MATANUSKA-SUSITNA BOROUGH PLATTING BOARD AGENDA

MATANUSKA-SUSITNA BOROUGH PLATTING BOARD AGENDA FEBRUARY 20, 2020

A. LANIKAI ESTATES LLC: The request is create a t-turnaround Public Use Easement at the western terminus of E. Wagonwheel Drive, in Tax Parcel A7, to be known as **OSTERMILLER PUE**, containing 13,286 sf +/- . The proposed Public Use Easement is located west of E. Wagonwheel Drive, parcel is located west of N. Britchenstrap Drive and north of N. Farm Loop, (Tax ID #118N02E18A007); within the E ½ W ½ NE ¼ Section 18, Township 18 North, Range 02 East, Seward Meridian. Community Council Farm Loop and in Assembly District #1 Tim Hale

B. MARY SUSANNE GOODWIN: The request is to create a 58-lot, 2-phase master plan known as **GOODWIN ESTATES**, containing 80 acres +/- . The property is located west of N. Palmer-Fishhook Road and north of E. Tex-Al Drive (Tax ID #18N01E10C007 & 18N01E10D006); within the S ½ Section 10, Township 18 North, Range 01 East, Seward Meridian. Community Council: Fishhook and in Assembly District #6 Jesse Sumner

DWG.#: 19-282C
DESIGN: CEH
DRAWN BY: SDN
CHECKED: CEH
SCALE
11x17: 1" = 40'
22x34: 1" = 20'
REVISION DATE:
01-17-20

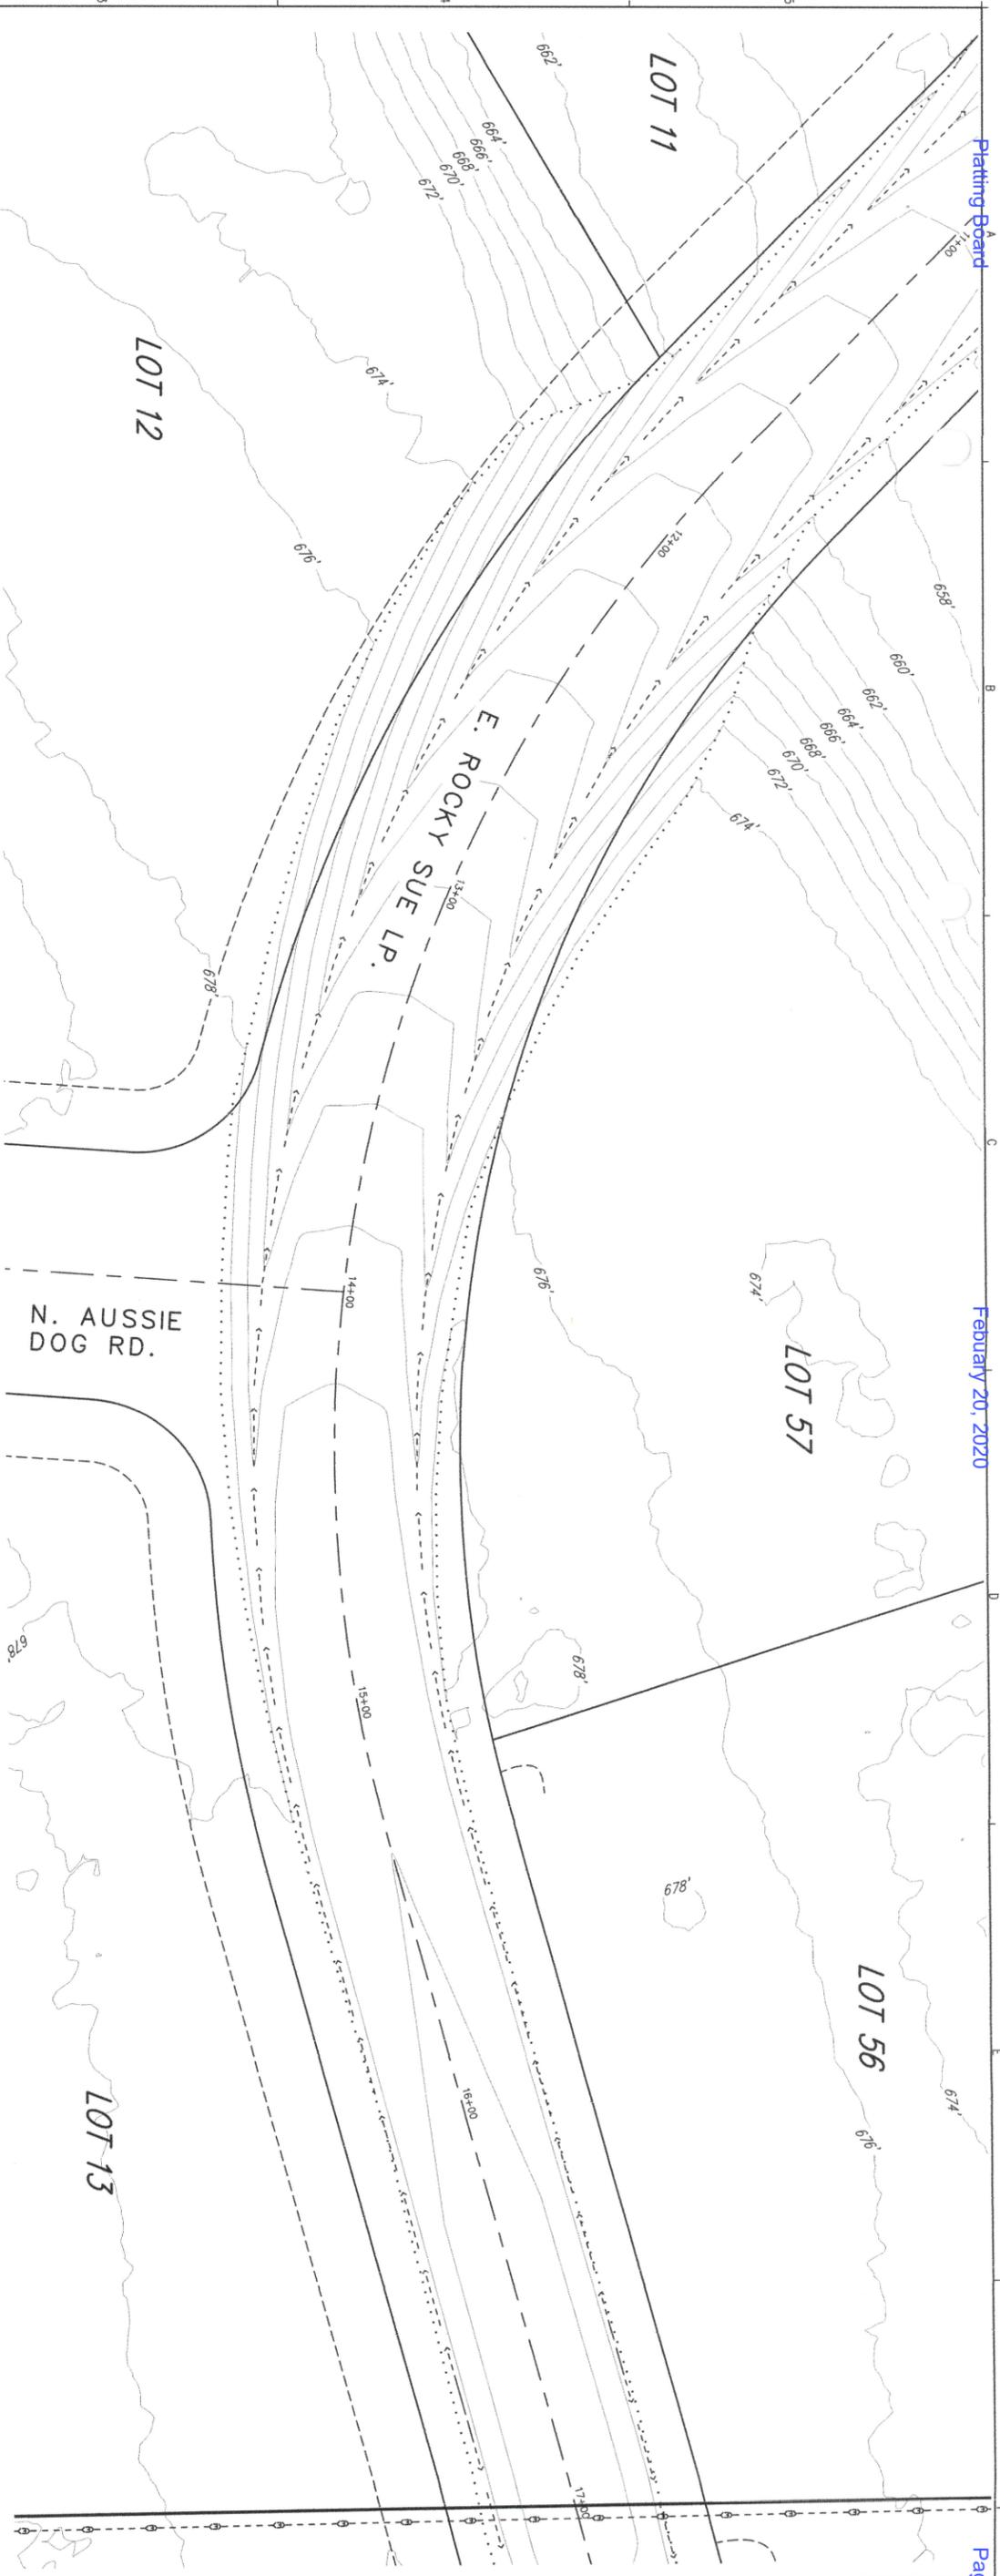
- I approve the less than 350' radii horizontal curves due to the site constraints as stated in the surveyor's letter.
- Plan & profile – A05.5 f) requires maximum grade of 7% within 50 feet of an intersection on the through road – check this at the intersection of the two stub roads with the loop road.

EXHIBIT I

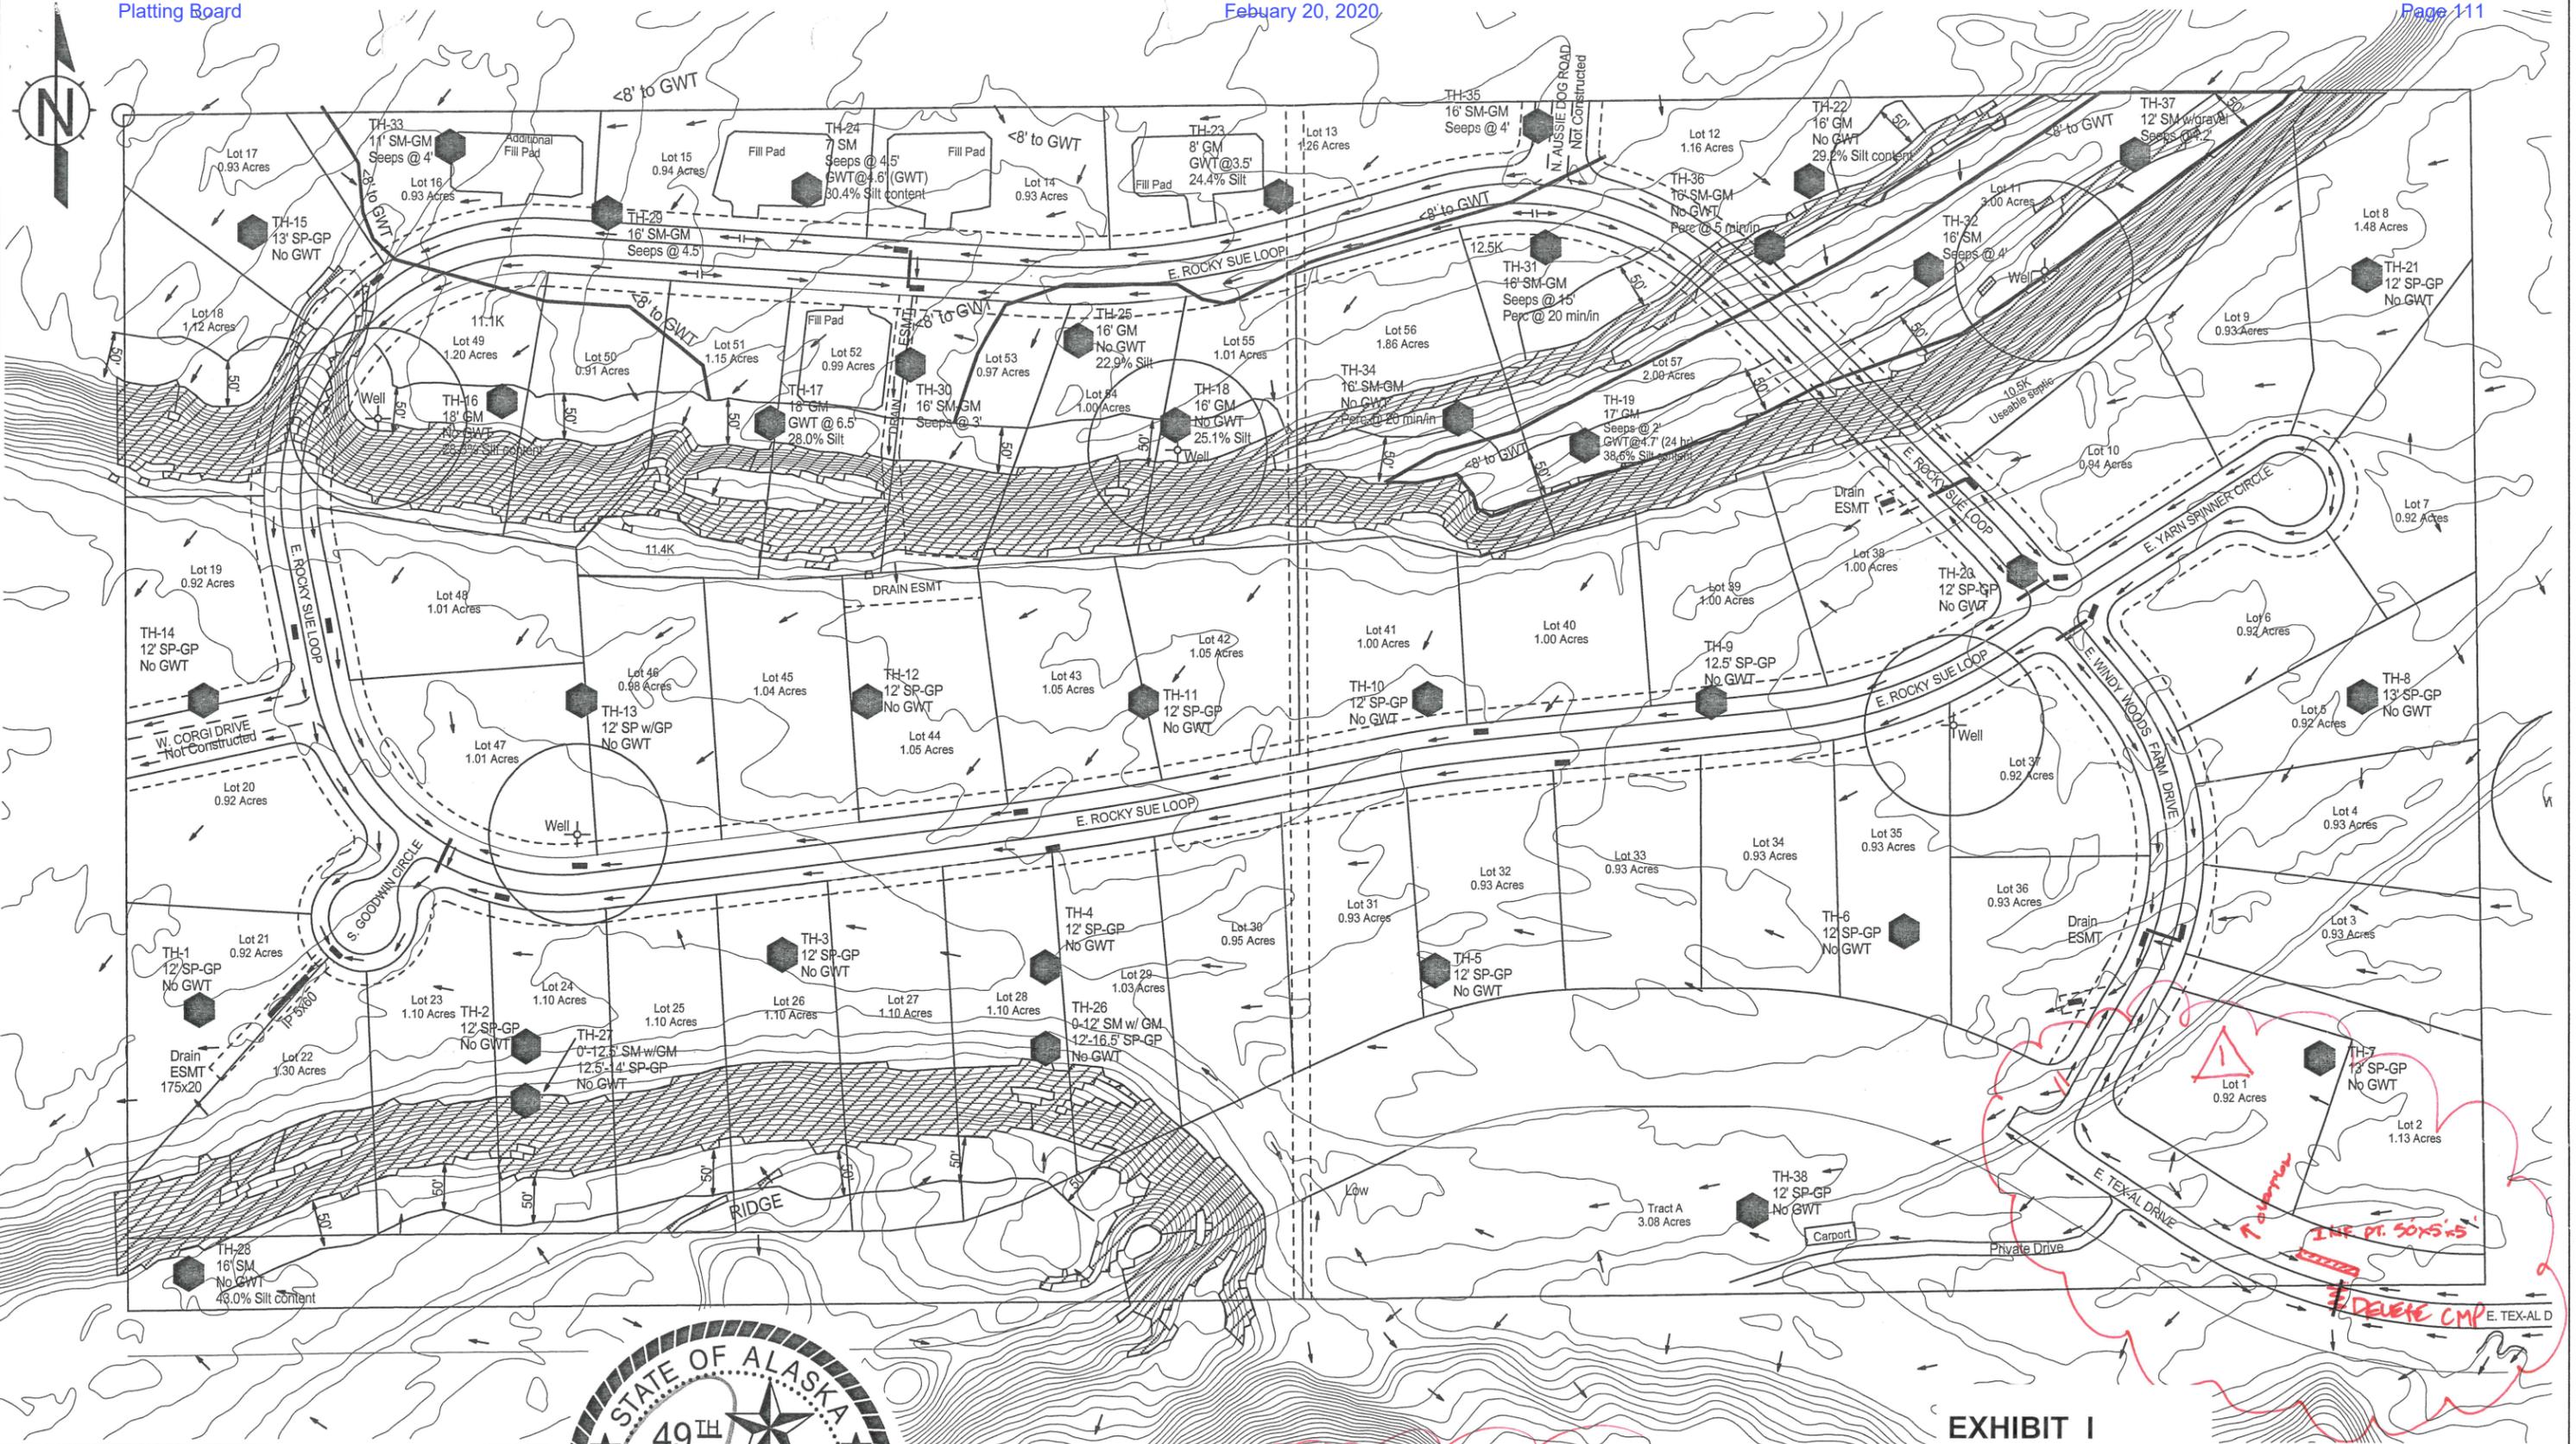
*UPDATE 2-06-2020
DELETE CMP, ADD I P*
